Access Compliance Report

Public Rights-of-Way

Intersection ID: 44016	Main Street: ATWATER_LN	Cross Street: MANTARIO_DR	Location: E
ADA ID: 8B40735BD266	Ramp Type: PerpDiag	Initial Pass/Fail: Fail	Overall Compliance: No
		Severity Score: 17.5

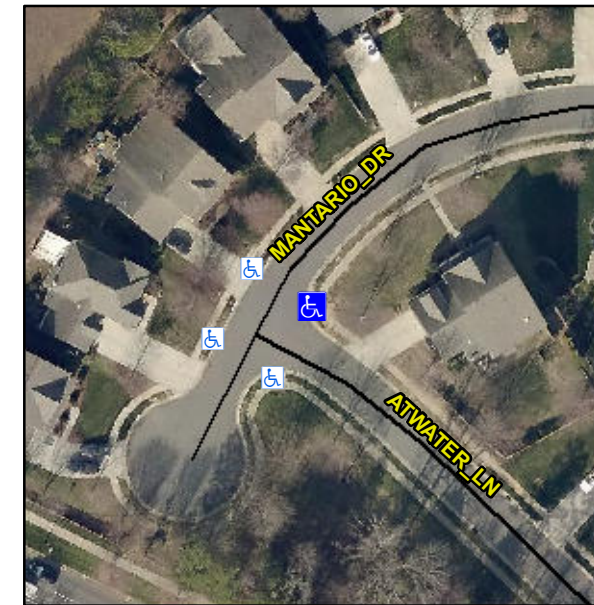
R304.5.1

Compliance	Description	Data	Compliance	Description	Data
N/A	Ramp Length (in)	45.5	Yes	Ramp Slope (%)	5.9
No	Ramp Width (in)	34.0	Yes	Ramp XSlope (%)	0.6
N/A	Flare Type LT	N/A	N/A	Flare Type RT	N/A
N/A	Flare Slope LT (%)	N/A	N/A	Flare Slope RT (%)	N/A
N/A	Flare Traversable LT?	N/A	N/A	Flare Traversable RT?	N/A
N/A	Landing Length (in)	N/A	N/A	DWS Provided?	N/A
N/A	Landing Width (in)	N/A	N/A	DWS Contrast?	N/A
N/A	Landing Slope (%)	N/A	N/A	DWS Length (in)	N/A
N/A	Landing X Slope (%)	N/A	N/A	DWS Full Width?	N/A
N/A	Landing Curb? (Y/N)	N/A	N/A	DWS Offset (in)	N/A
N/A	Shared Landing?	N/A			
N/A	Gutter Ponding?	N/A	N/A	Gutter Slope (%)	N/A
N/A	Gutter Lip Ht (in)	N/A	N/A	Gutter X Slope (%)	N/A
N/A	Painted X Walk1?	No	N/A	Painted X Walk2?	No
	X Walk 1 Direction	To NW		X Walk 2 Direction	To SW
N/A	X Walk 1 Width (in)	N/A	N/A	X Walk 2 Width (in)	N/A
	X Walk 1 Slope (%)	0.9		X Walk 2 Slope (%)	0.4
	X Walk 1 X Slope (%)	3.7		X Walk 2 X Slope (%)	1.9

Remove & Replace Curb Ramp With Two New Directional Ramps or Equivalent.
